GLYNNWOOD TRIBUTARY AREA STORM SEWER SYSTEM CLASS ENVIRONMENTAL ASSESSMENT

SUPPORTING DOCUMENTS RELATED TO THE DEVELOPMENT OF REVISED PREFERRED ALTERNATIVE (JANUARY 2021)

LIST OF SUPPORTING DOCUMENTS RELATED TO THE DEVELOPMENT OF REVISED PREFERRED ALTERNATIVE

\\S []		
		Checked A.Z.Z.	Drawn AutoCAD/B.K.B./A.Z.Z.	
rio 2 (No Site). Rev 3	z	Date JANUARY 2021	Proj. No. 121-15461-00	
Sile). Rev .)	Scale AS SHOWN	Figure No. X4.R3 Gr.No. 00

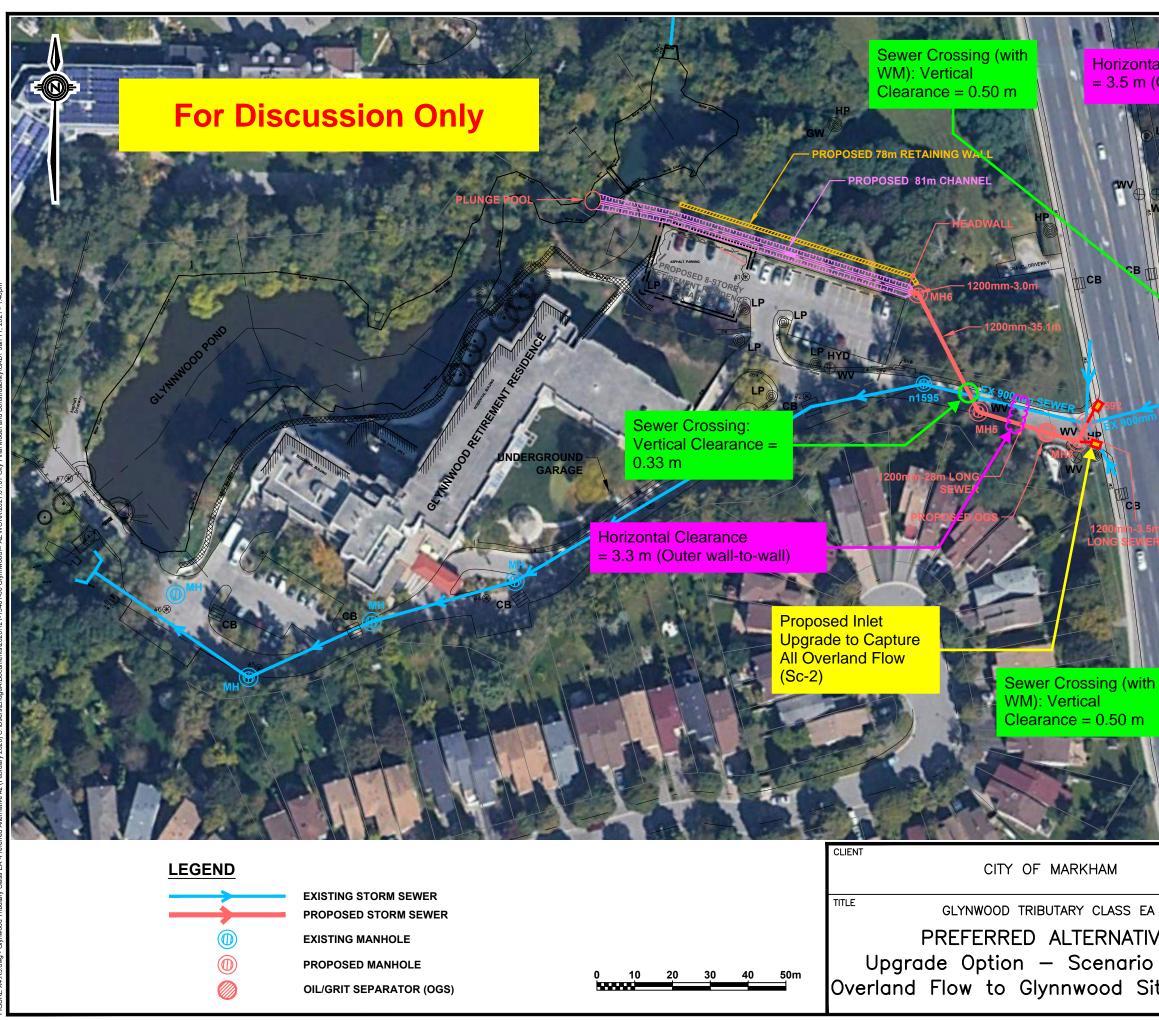
Further to our Technical Memo dated December 18, 2020 (attached), as per your request, we have revised the alignment of the proposed sewer at the Glynnwood property driveway.

Constructability of the proposed system was also evaluated based on the vertical and horizontal clearances between the elements. The detailed results are illustrated in **Figure X4.R3**. All supporting documents are attached for reference.

SD SD
EA		
/E #2	Checked A.Z.Z.	Drawn AutoCAD/B.K.B.
	Date DEC 2020	Proj. No. 121-15461-00
erland Flow to 2	Scale AS SHOWN	Figure No. X4.R2 Gr.No. 00

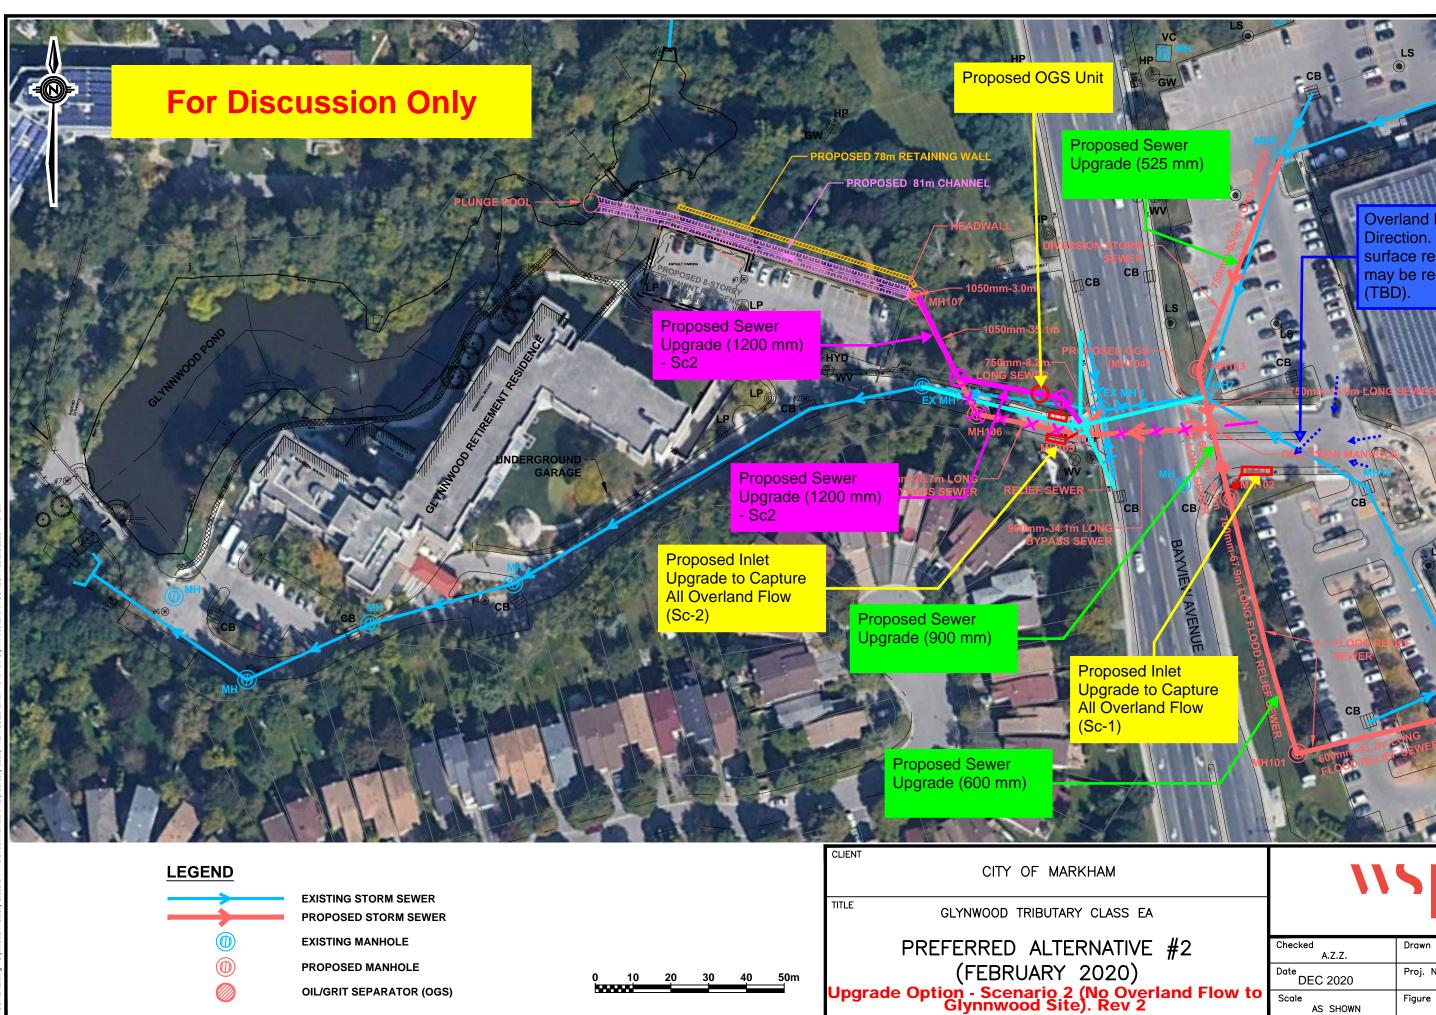
1 Regarding the STM survey completed by the City, there is an inconsistency of the upstream inverts for the existing 900 mm pipe across Bayview Ave. The surveyed US invert of such pipe is 165.528 m, while the surveyed DS invert is unknown. The 167M-2 as-built drawing has both US and DS inverts for this pipe. By applying the as-built DS invert with the surveyed US invert, it results in an negative slope in the sewer, which does not make sense. Moreover, the as-built was deemed to be more accurate because it also contained the 1800 mm watermain data and correct sewer sizes. Therefore, the inverts of the existing 900 pipe across Bayview Ave were based on the as-built 167M-2 drawing.

2 By using the data colleceted based on the recent City's STM survey, the updated Infoworks model confirms that the new STM relief pipe across the Bayview Avenue (as previously proposed) will not be necessary. The proposed system upgrades required on both TSSC site (east of Bayview) and Glynnwood site (west of Bayview) will be sufficient to convey flows (up to 100-year event) and solve the flooding issues at the TSSC site. An illustration of the

revised proposed system is shown in **Figure X4.R2**. Detailed proposed sewer profiles are included in the attachement.

- 3 The vertical clearance between the existing STM and the proposed pipes were evaluated at two locations east of Bayview Ave. It is confirmed the vertical clearance of 0.5 m will be achieved. The 0.5 m is the minimum clearance as stated in City of Markham's Subdivision Requirements. Detailed locations of the clearance check are are included in the attachement.
- 4 The proposed OGS unit will be relocated to the west of Bayview Ave., as shown in **Figure X4.R2**.
